UNITED STATES OF AMERICA
NUCLEAR REGULATORY COMMISSION

(Comanche Peak Steam Electric Station
Station, Units 1 and 2)

Docket Nos. 50-445-1 and
50-446-1

CASE'S ANSWER TO APPLICANTS' STATEMENT OF MATERIAL FACTS
AS TO WHICH THERE IS NO GENUINE ISSUE REGARDING
CERTAIN CASE ALLEGATIONS REGARDING AWS AND ASME
CODE PROVISIONS RELATED TO DESIGN ISSUES

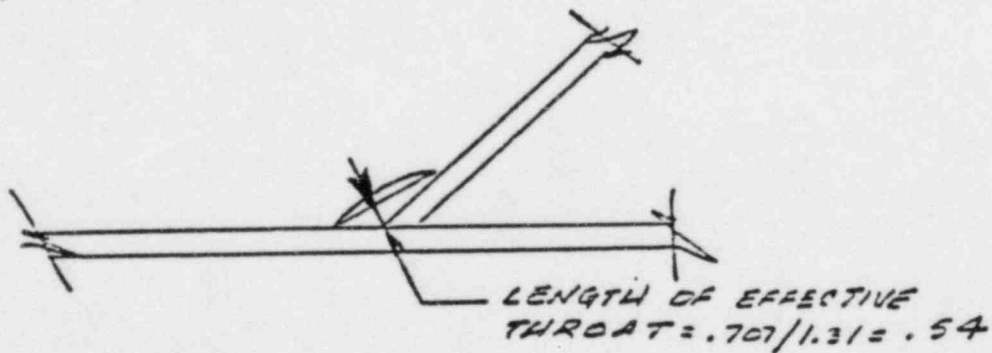
It is because of this .3 times yield strength provision that the ASME allowable appears to be more conservative. The reason it appears the ASME provision is more conservative is because it is based on yield strength; i.e., .3 times 42 ksi = 12.6 ksi, with no consideration for the effective throat. When the Applicants used the AWS procedure, it was based on tensile strength; that is, .3 times 70 ksi times .707 for the effective throat times a reduction for the skewed T-joint = 14.8 ksi, which would indicate that the capacity using the ASME procedure provides for a weaker or more conservative weld capacity. It should be noted that the example used by the Applicants did not consider the effective throat when using the ASME procedure, but was actually only evaluating the weld at the interface between the base metal and the

weld (shown as line A in the diagram below). In the example for the AWS procedure, the Applicants are looking at the capacity of the weld (shown as line B in the diagram below).

For a member that is skewed and welded on only one side of the skewed joint, as shown in the diagram below, the capacity of the joint using the AWS procedure for the angle shown is equal to .3 times 70 ksi times .707 for the effective throat times 1.31 the coefficient set forth in Appendix B, Table B, of the AWS Code = 11.3 kips/inch.

This value is less than the ASME allowable value of 12.6 kips/inch. So in this regard, the AWS code is more conservative than the ASME code.

FIGURE 3

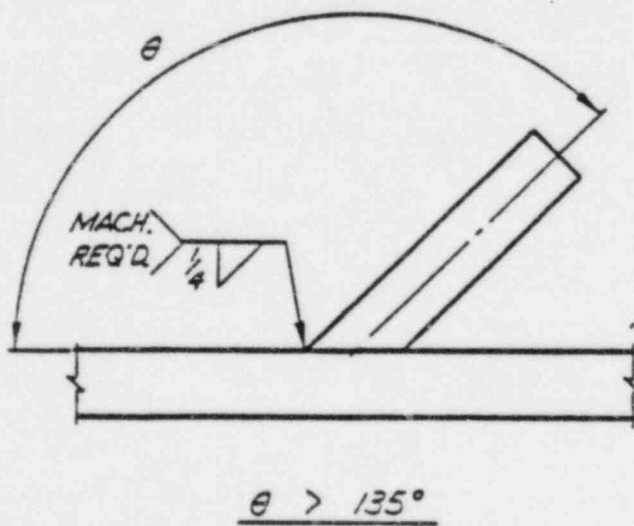
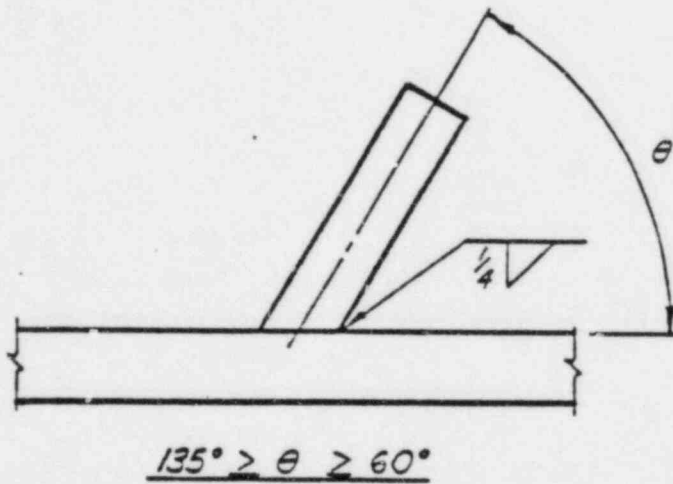
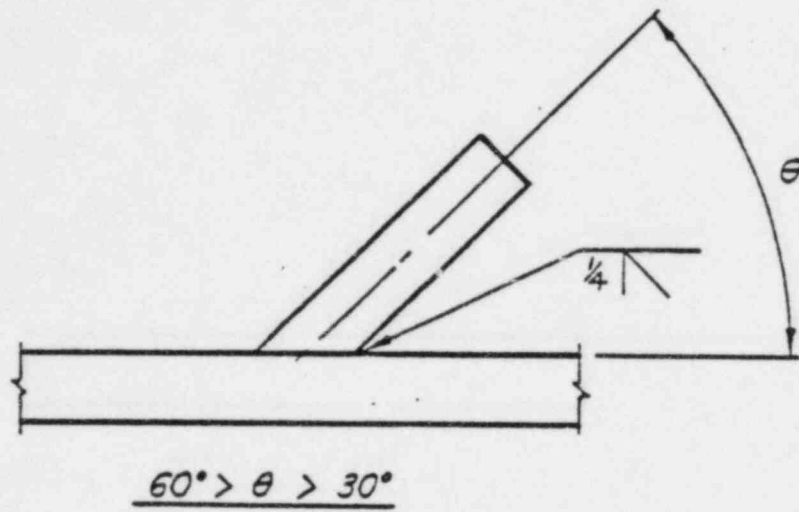
I disagree with this statement. In the first place, the type of information which should be considered to be "documentation" is such as that contained in the PSE Manual. As shown by the attached pages from the PSE Manual (cover page, pages 1 and 2, and Figure 3, of Section XI, Weld Calculations, from CASE Exhibit 716, which was provided to the Board and parties but never officially accepted into evidence), in the procedures being used as of 5/11/82, Applicants did not include information as to how to calculate the effective throat. This appears to be in violation of 10 CFR Part 50, Appendix A, Criterion 1, in that Applicants should have incorporated Appendix B, Table B, of AWS D1.1 into their procedures to calculate the effective

throat of a skewed fillet weld, since ASME does not contain such a table and is therefore not sufficient.

As indicated in the CPPA-22,616 memorandum, the welds in question are those welds which are greater than 90 degrees but still less than 135 degrees. In diagram B of Attachment 1 to CPPA-22,616, the diagram indicates that the size of weld (not the effective throat that engineering was using) was a value S, but does not state how the effective throat is calculated. If engineering is using the value S as the effective throat, they are grossly in error. As shown in Table B of Appendix B of the AWS Code, when a 1" weld is sized when the members are perpendicular to one another, the size of fillet weld required to provide the same capacity increases to 1.31" when the members are at 135 degrees to one another.

This above information is not contained in any of the information provided by the Applicants. Therefore, any conclusions that the Applicants have attempted to provide indicating the present designs are equal to or compatible with the AWS requirements is unsubstantiated. Further, there is no substantiation for the statement that what was being used was "virtually identical to that noted in Appendix B of AWS D1.1 regarding effective throat thickness for skewed T-joint welds."

| <table border="1"> <tr> <th>DESIGN LOADS</th> <th>MVS (IN-1)</th> <th>SEISMIC</th> <th>REFERENCE DRAWINGS</th> <th>ISOMETRIC</th> <th>REV</th> <th>PIPING</th> <th>REV</th> <th>ELECTRICAL</th> <th>REV</th> <th>CODE/CLASS</th> <th>REV</th> <th>DRAWN</th> <th>DATE</th> <th>CHK'D</th> <th>DATE</th> <th>APP'VD</th> <th>DATE</th> </tr> <tr> <td></td> <td></td> <td></td> <td></td> <td></td> <td></td> <td></td> <td></td> <td></td> <td></td> <td></td> <td></td> <td></td> <td></td> <td></td> <td></td> <td></td> <td></td> </tr> </table> | DESIGN LOADS | MVS (IN-1) | SEISMIC | REFERENCE DRAWINGS | ISOMETRIC | REV | PIPING | REV | ELECTRICAL | REV | CODE/CLASS | REV | DRAWN | DATE | CHK'D | DATE | APP'VD | DATE | | | | | | | | | | | | | | | | | | | <table border="1"> <tr> <td>OWNER</td> <td>TEXAS UTILITIES SERVICES</td> <td>NC.</td> </tr> <tr> <td>PROJECT</td> <td>COMANCHE PEAK UNITS NO. 1 & 2</td> <td></td> </tr> <tr> <td>ENGINEER</td> <td>GIBBS & HILL INC.</td> <td></td> </tr> </table> | OWNER | TEXAS UTILITIES SERVICES | NC. | PROJECT | COMANCHE PEAK UNITS NO. 1 & 2 | | ENGINEER | GIBBS & HILL INC. | | <table border="1"> <tr> <td>BI SUPP'T. 150.</td> <td>NPSI-MS-1-RB-02</td> </tr> <tr> <td>REV</td> <td>3333-F</td> </tr> <tr> <td>REV</td> <td>3333-M</td> </tr> <tr> <td>REV</td> <td>3333-B</td> </tr> </table> | BI SUPP'T. 150. | NPSI-MS-1-RB-02 | REV | 3333-F | REV | 3333-M | REV | 3333-B | <table border="1"> <tr> <td>REV</td> <td>3333-F</td> </tr> <tr> <td>REV</td> <td>H.V.A.C.</td> </tr> <tr> <td>REV</td> <td>3333-M</td> </tr> </table> | REV | 3333-F | REV | H.V.A.C. | REV | 3333-M | <table border="1"> <tr> <td>PAINT</td> <td>CAH/PA/IN</td> </tr> <tr> <td>ZONE</td> <td>~</td> </tr> </table> | PAINT | CAH/PA/IN | ZONE | ~ | <table border="1"> <tr> <td>P.O. NO.</td> <td>CP-0044A.1</td> <td>MFG. RES.</td> <td></td> </tr> <tr> <td>PRODUCTION ORDER</td> <td></td> <td>SERIAL NUMBER</td> <td></td> </tr> <tr> <td></td> <td></td> <td></td> <td>SHEET 30 OF 5</td> </tr> </table> | P.O. NO. | CP-0044A.1 | MFG. RES. | | PRODUCTION ORDER | | SERIAL NUMBER | | | | | SHEET 30 OF 5 |
|---|-------------------------------|---------------|--------------------|--------------------|-----------|--------|--------|------------|------------|------------|------------|---|-------|--------------------------|--------|--------|--------|------|--|--|--|--|--|--|--|--|--|--|--|--|--|--|--|--|--|--|---|-------|--------------------------|-----|---------|-------------------------------|--|----------|-------------------|--|--|-----------------|-----------------|-----|--------|-----|--------|-----|--------|---|-----|--------|-----|----------|-----|--------|--|-------|-----------|------|---|---|----------|------------|-----------|--|------------------|--|---------------|--|--|--|--|---------------|
| 137 | WK. NO. MS-1-01-001-C725 | REV. 5 | | | | | | | | | | | | | | | | | | | | | | | | | | | | | | | | | | | | | | | | | | | | | | | | | | | | | | | | | | | | | | | | | | | | | | | | | | | | | | |

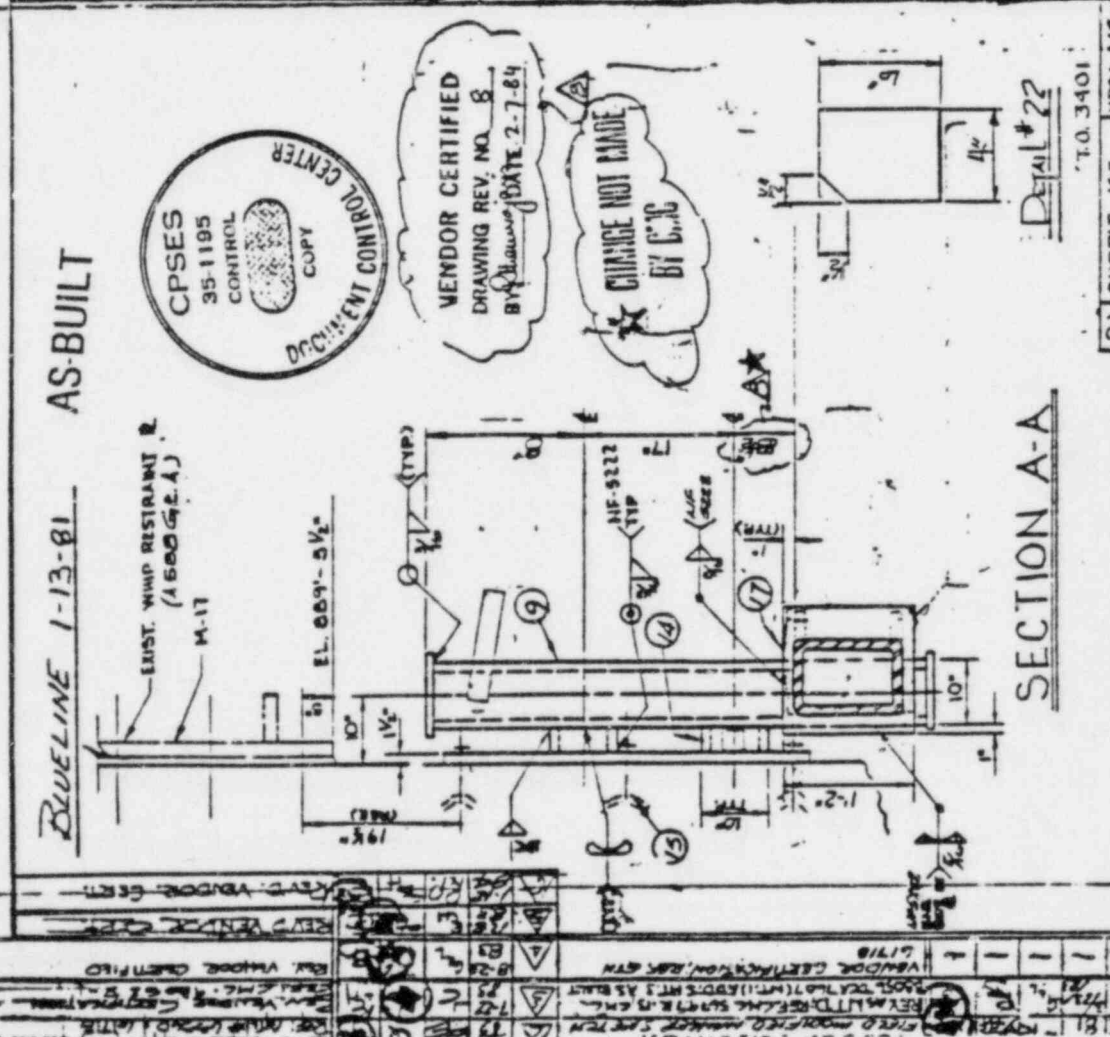
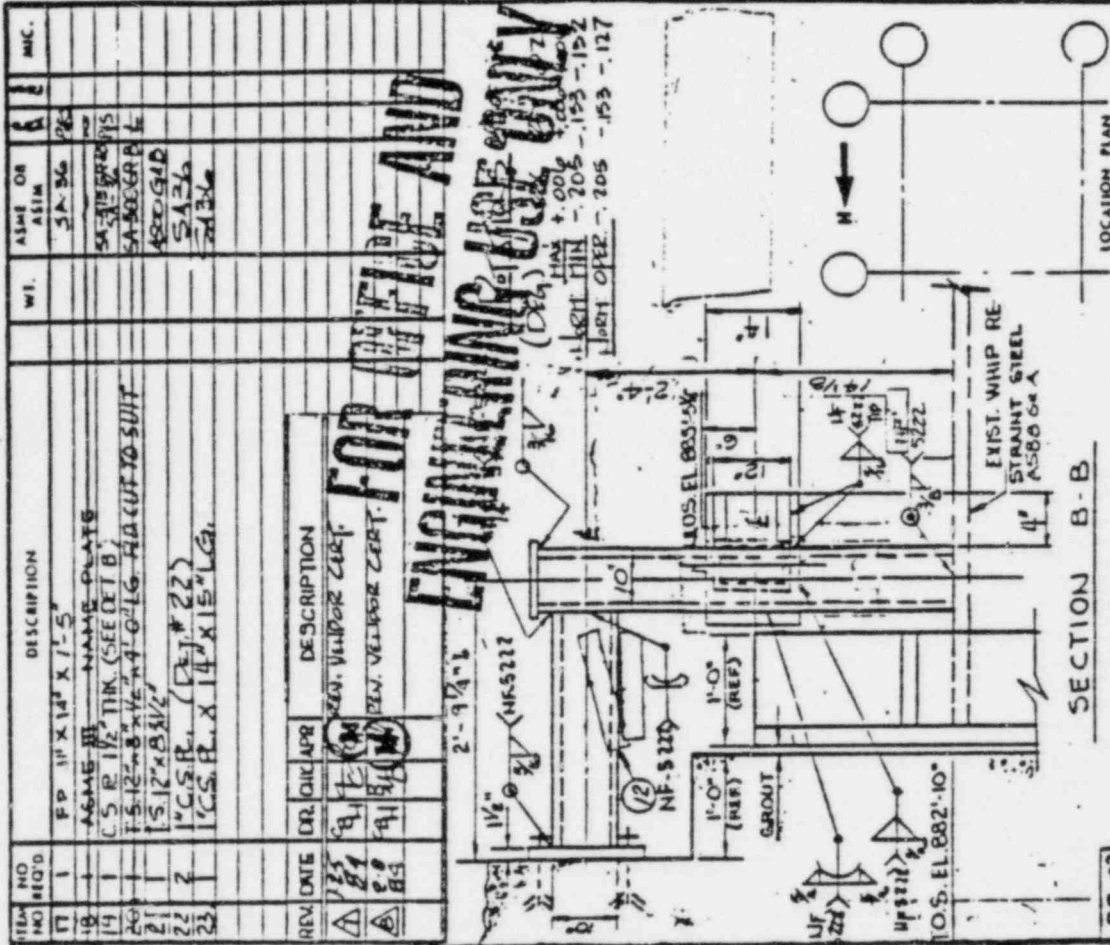
However, when CASE requested discovery regarding Applicants' generic stiffness study, the Applicants provided CASE with drawings that were utilized in determining support stiffnesses, as well as sample calculations. In this group of drawings, there were 32 supports that utilized tube steel members in bending, which I have reviewed for the thinness ratio for punching shear. Of these 32 supports, there were 6 cases (5 supports, with two examples on one support) where the thinness ratio was 10 or above; 5 cases exceeded 10 -- see attached drawings of Support Nos.:

MS-1-01-001-C72S, 8x6x3/8" = 10.7

This means that of the 32 supports which were in bending, 21 were equal to 8 or greater = 66%; and 5 of the 32 supports were equal to 10

or above = 16% which would have their shear capacity reduced by up to one-half. Five instances (four supports) were contained in these 32 supports where the chord thickness ratio was greater than the 10 which Applicants stated emphatically was the largest ratio which exists at CPSES. Although (I assume) that this statement by Applicants was not made under oath, it appears at a minimum to be an attempt to mislead the NRC Staff in its evaluation regarding this matter.

SUPPORT NO.: CC-E-011-71P-AS225
SHEET: 1 OF 1
REV.:

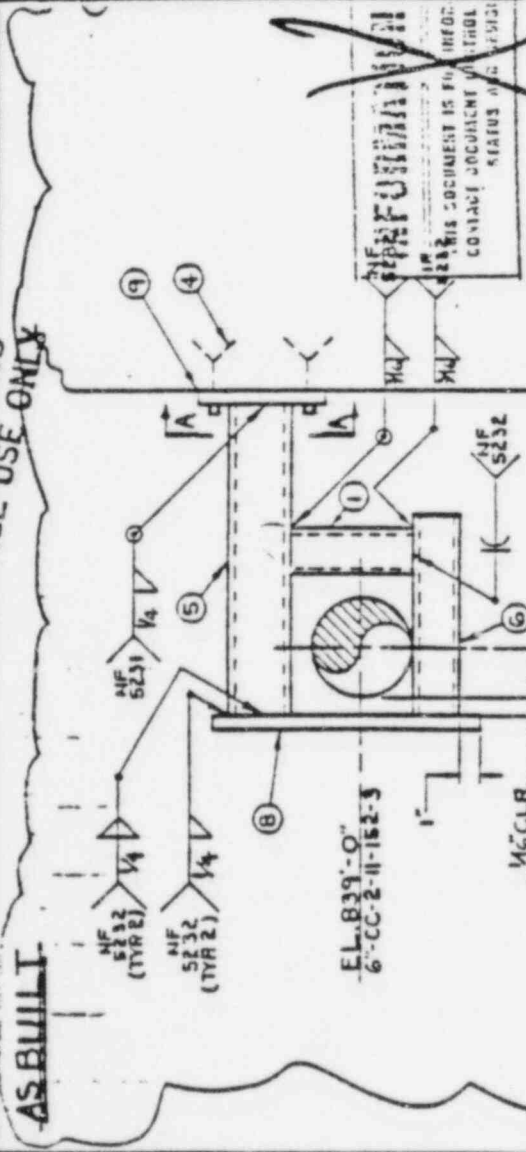
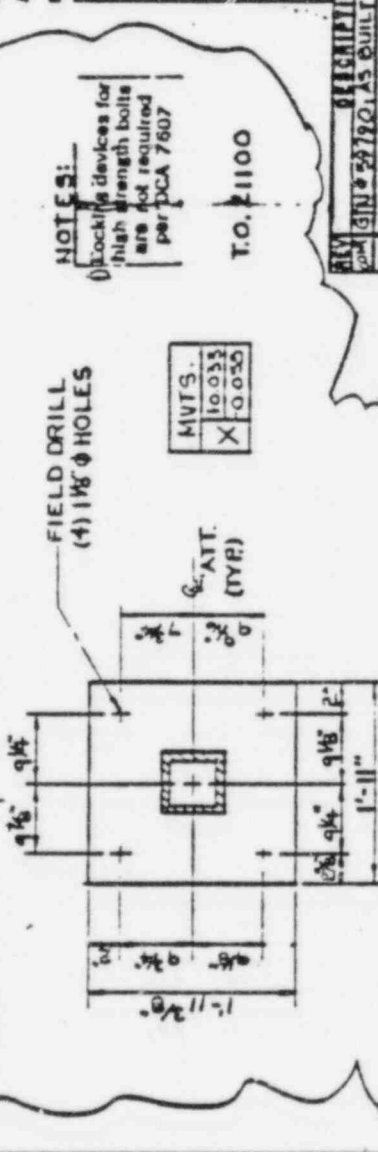
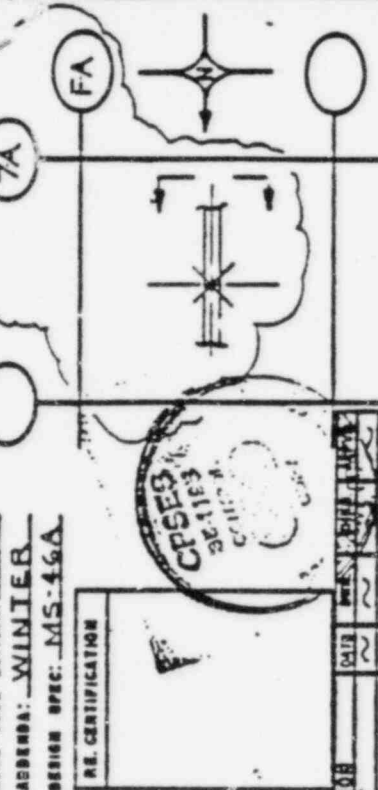
CC-2-011-711-A53R, 6x6x1/4" = 12

CC-2-011-712-A53R, 6x6x1/4" = 12
